Form 1 – Responsible Authority Report (Regulation 12)

Property Location:	Lot 636 Thundelarra Drive, Golden Bay
Development Description:	Mixed Use Development comprising 101 Independent Living Apartments, Café, Retail, Community Shared Spaces, Residential Amenities and associated Parking
DAP Name:	Metro South-West JDAP
Applicant:	The Klopper Family Trust & The Davis Family Trust
Owner:	636 Golden Bay Pty Ltd
Value of Development:	\$15.5m
LG Reference:	DD020.2019.193.1
Responsible Authority:	City of Rockingham
Authorising Officer:	Bob Jeans, Director Planning & Development Services
DAP File No:	DAP/19/01646
Report Due Date:	22nd October 2019
Application Received Date:	5th August 2019
Application Process Days:	
Attachment(s):	<ol style="list-style-type: none">1. SPP7.3 Assessment2. Design Review Panel Meeting Notes3. Cover Letter4. Development Application Report5. Architectural Drawings6. Area Schedule7. Conceptual Renders8. Landscape Report9. Waste Management Plan10. Traffic Impact Statement and Parking Control Management Plan11. Stormwater Management Plan12. Acoustic Report13. Swept Path analysis14. Schedule of Submissions

Refuse DAP Application reference DAP/18/01463 and accompan

DIAGRAM - PROPOSED SETBACK DIMENSIONS

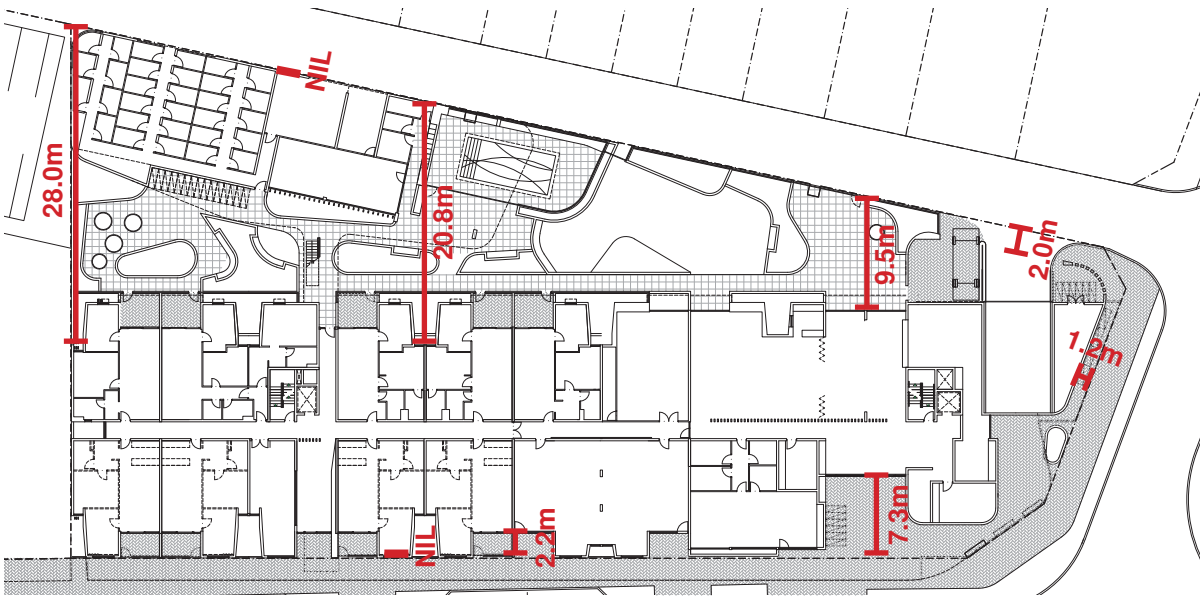
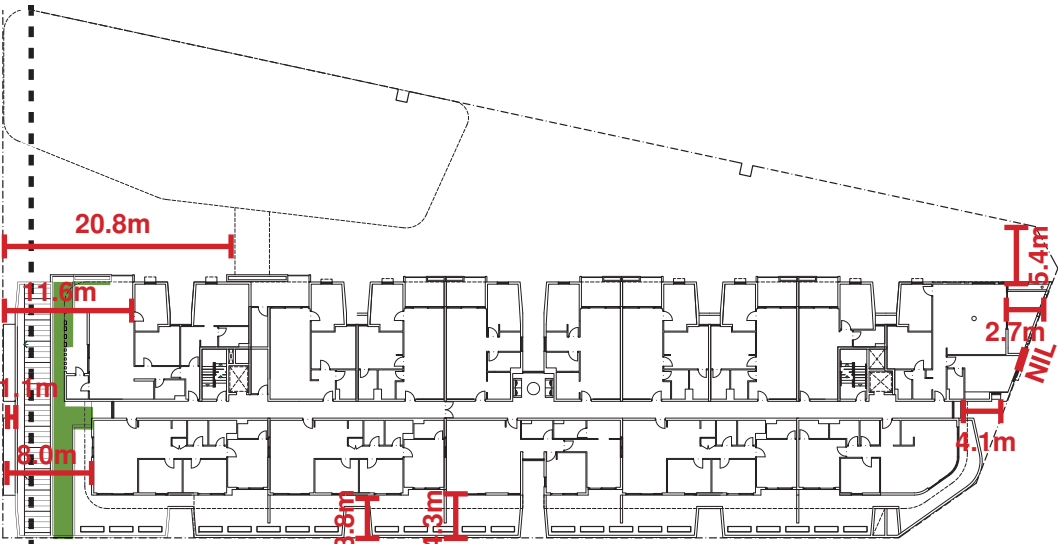
The previously approved scheme was approved with Nil side & rear setbacks thus the proposed scheme is also supportable by council. The proposed scheme has been further refined and presents a far better architectural outcome to the Child Care Centre.

DIAGRAM - PROPOSED SCHEME (PARKLANDS INSTEAD OF ON-GRADE CARPARK)

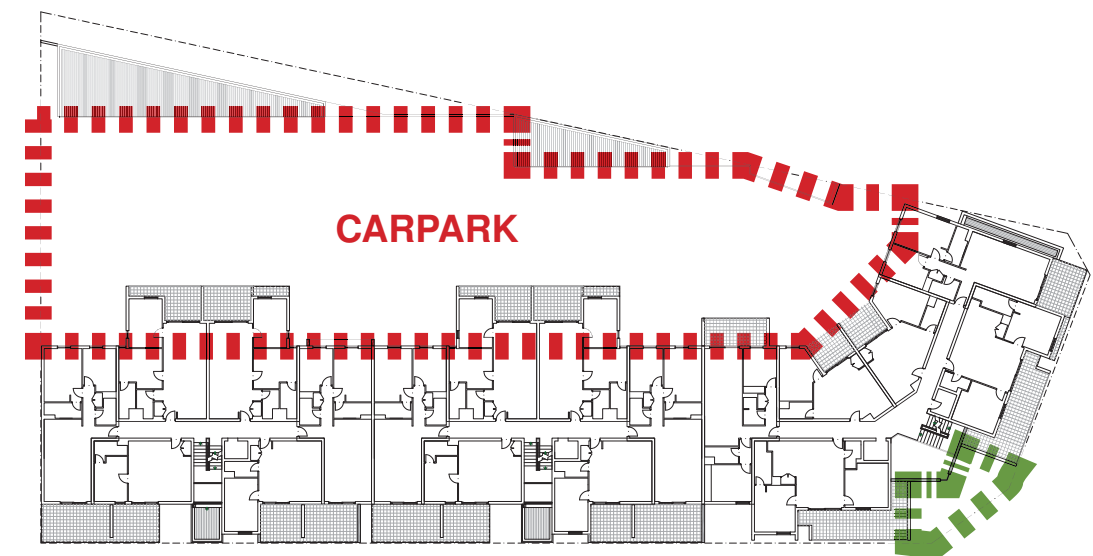
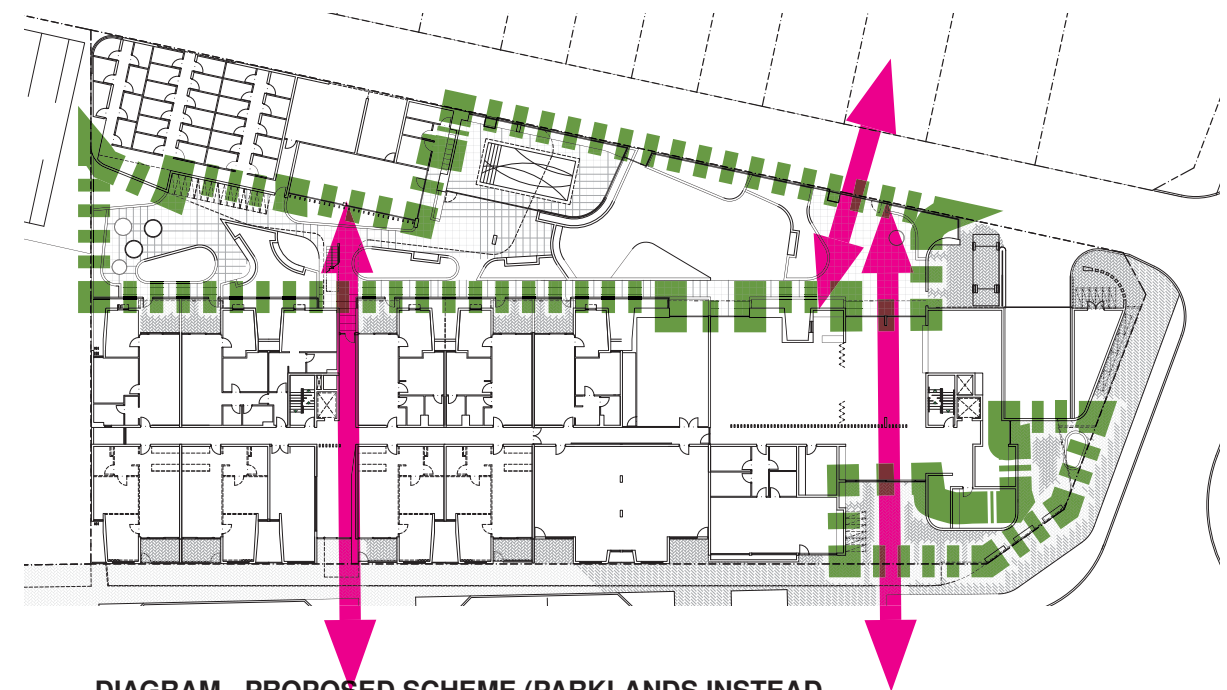
The previously approved scheme proposed 1,225m² of open space but over 90% of this was carparking which offers no amenity to residents, neighbours or the greater public.

The houses along Jundee Lane were presented with visitor car bays and 3.0H solid walls. Our current scheme gives back to the community, allowing views and connections through to the parklands. Infact, ~40m of the site boundary of the revised scheme is semi-permeable as opposed to the previously approved scheme which only had ~7m. It is clear that our revised scheme is a far superior outcome and is thus supportable by council.

DIAGRAM - OVERSHADOWING REVISED SCHEME

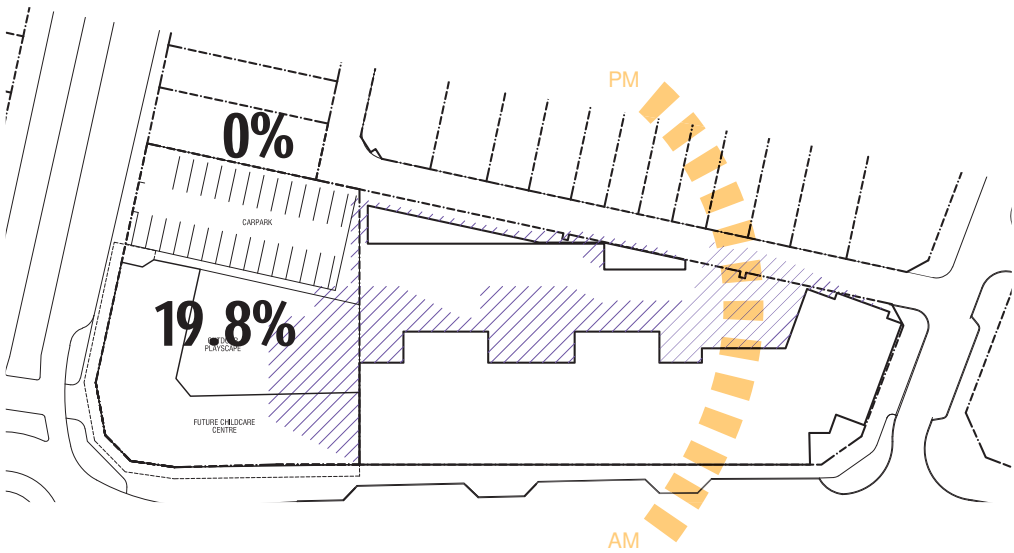
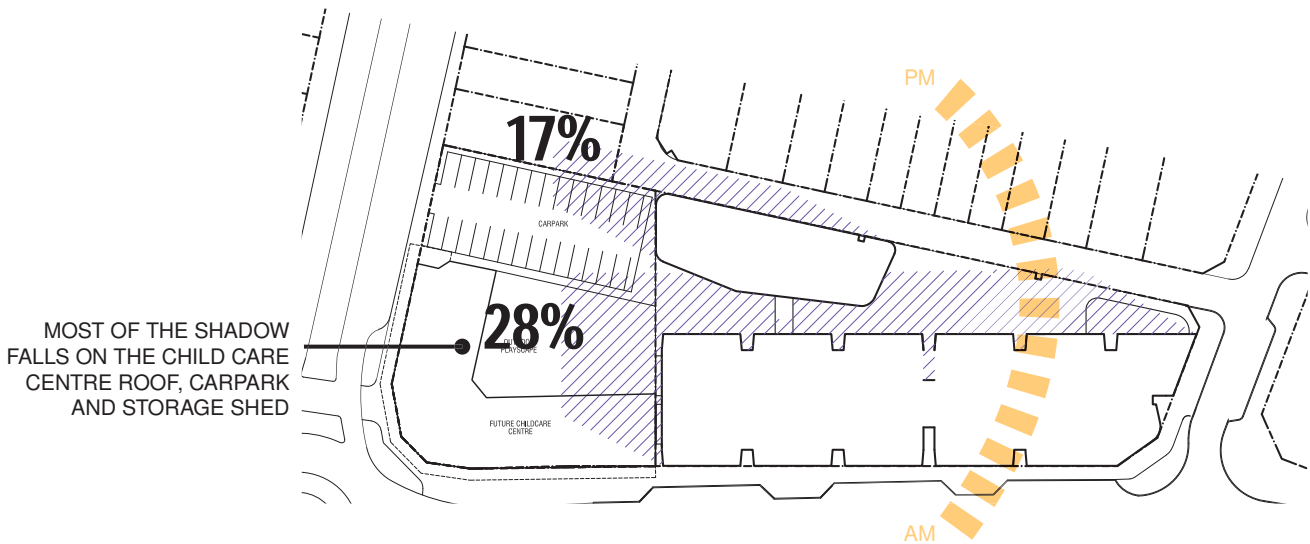
The proposed scheme overshadows the Child Care Centre lot 8.2%% more than the previously approved scheme which is again negligible. Therefore, the current proposal is supportable by council.
